Access Compliance Report Public Rights-of-Way (Curb Ramps)

Main Street: SANTIAGO_CANYON_RD Cross Street: ORANGE_PARK_BLVD Location: NW

ADA ID: RPRK211222133645 Ramp Type: Type 1 - Perpendicular Initial Pass/Fail: Fail Overall Compliance: No Severity Score: 15

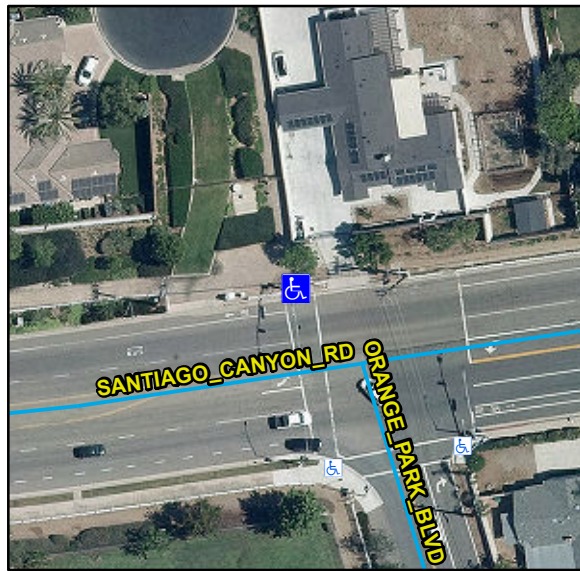
Compliance	Description	Data	Compliance	Description	Data
N/A	Ramp Length (in)	77	N/A	Flare Type LT	
Yes	Ramp Width (in)	48			N/A
No	Ramp Run Slope (%)	10.4	N/A	Flare Slope LT (%)	N/A
Yes	Ramp Cross Slope (%)	3.3	N/A	Flare Traversable LT	N/A
N/A	Landing Present	N/A	N/A	Flare Type RT	
N/A	Landing Length (in)	N/A			N/A
N/A	Landing Width (in)	N/A	N/A	Flare Slope RT (%)	N/A
N/A	Landing Run Slope (%)	N/A	N/A	Flare Traversable RT	N/A
N/A	Landing Cross Slope (%)	N/A	N/A	DWS Provided	N/A
N/A	Landing Movement Obstructed?	N/A	N/A	DWS Contrast	N/A
	Landing Movement Type	N/A	N/A	DWS Length (in)	N/A
N/A	Landing Shared	N/A	N/A	DWS Full Width	N/A
N/A	Clear Space	N/A	N/A	DWS Offset Left (in)	N/A
N/A	Clear Space To Crosswalk (in)	N/A	N/A	DWS Offset Right (in)	N/A
N/A	Marked Crosswalk 1	Yes	N/A	Marked Crosswalk 2	N/A
	Crossing 1 Direction	S		Crossing 2 Direction	N/A
	Marked Crosswalk 1 Width (in)	144		Marked Crosswalk 2 Width (in)	N/A

N/A	Ramp Inside Crosswalk 1	Yes	Yes	Ramp Inside Crosswalk 2	N/A
	Crossing 1 Slope (%)	1.4		Crossing 2 Slope (%)	N/A
	Crossing 1 Cross Slope (%)	3.4		Crossing 2 Cross Slope (%)	N/A
N/A	Gutter Ponding	N/A	N/A	Curb Slope	1.9
No	Gutter Lip Height (in)	0.25		Road Run Slope (%)	N/A
N/A	Gutter Run Slope (%)	N/A		Road Cross Slope (%)	N/A
N/A	Gutter Cross Slope (%)	N/A			
Yes	Overall Surface Condition: Acceptable		No	Perp Joint Present	No
	Cross Gutter Present?	No		Spandrel Present?	No
	Replace Cross Gutter?	N/A		Replace Spandrel?	N/A

Remove & Replace Entire Ramp. Grind Gutter Lip.

R204.3, R304.2.2, R302.7.2, STD 1115
